**Proposal #08: 5540-02-71, WISC 2024022**  
**Prairie du Chien - Viroqua**  
**0.1 M N North Avenue to CTH C**  
**STH 27**  
**Crawford County**

This is Addendum No. 01, which provides for the following:

**ADDENDUM NO. 01**

**5540-02-71**

Addendum No. 01  
 ID 5540-02-71  
 Revised Sheet 62  
 November 2, 2023

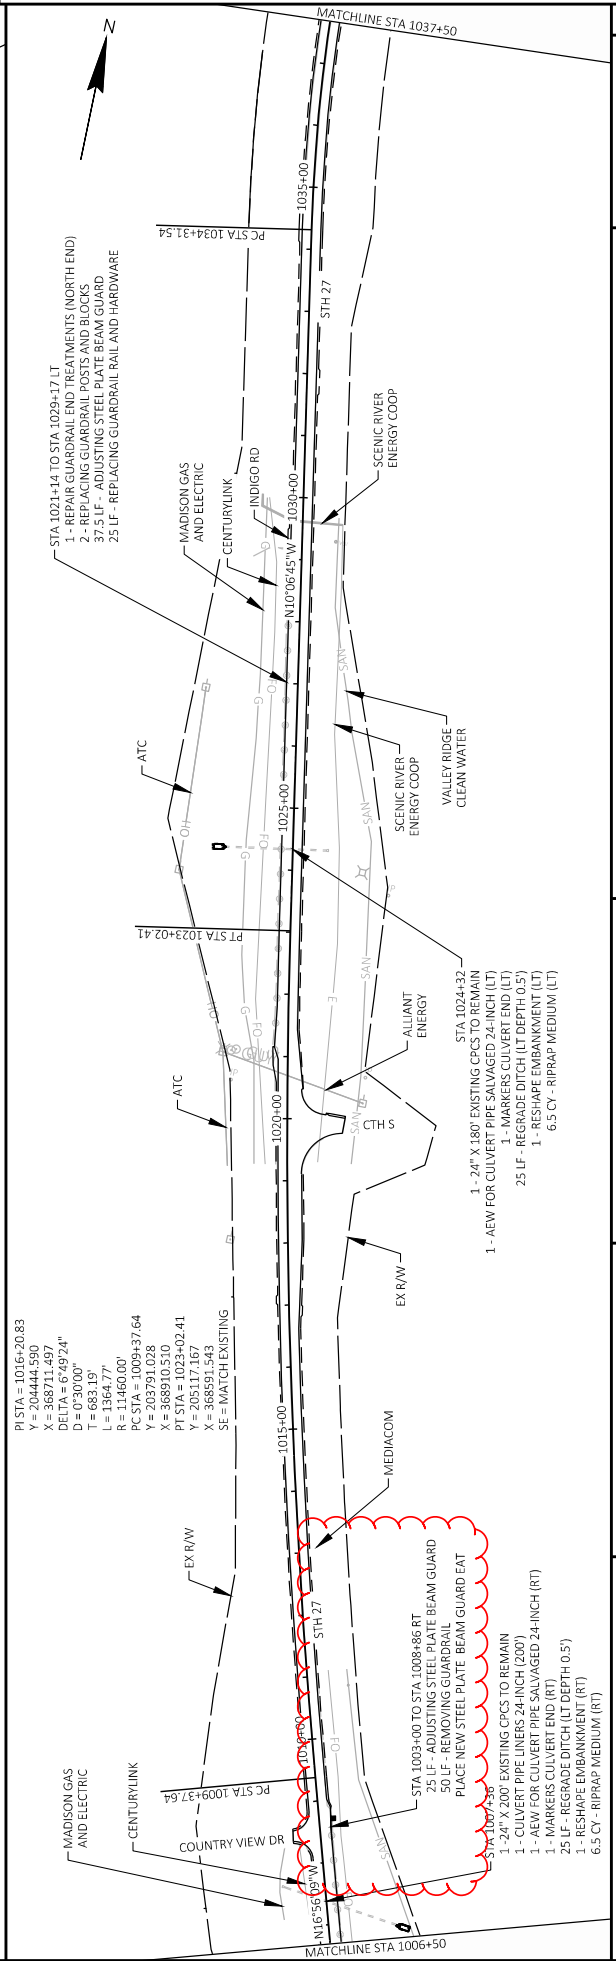
<b>Revised Plan Sheets</b>	
<b>Plan Sheet</b>	<b>Plan Sheet Title (brief description of changes to sheet)</b>
62	Revised Miscellaneous Quantity sheet to modify guardrail quantities and add new items
78	Revised Plan Sheets to update callout for Steel Plate Beam Guard EAT replacement

- STA 1021+14 TO STA 1029+17 LT  
 1- REMOVING GUARDRAIL (NORTH END)  
 2- REPLACING GUARDRAIL POSTS AND BLOCKS  
 37.5 LF - ADJUSTING STEEL PLATE BEAM GUARD  
 25 LF - REPLACING GUARDRAIL RAIL AND HARDWARE
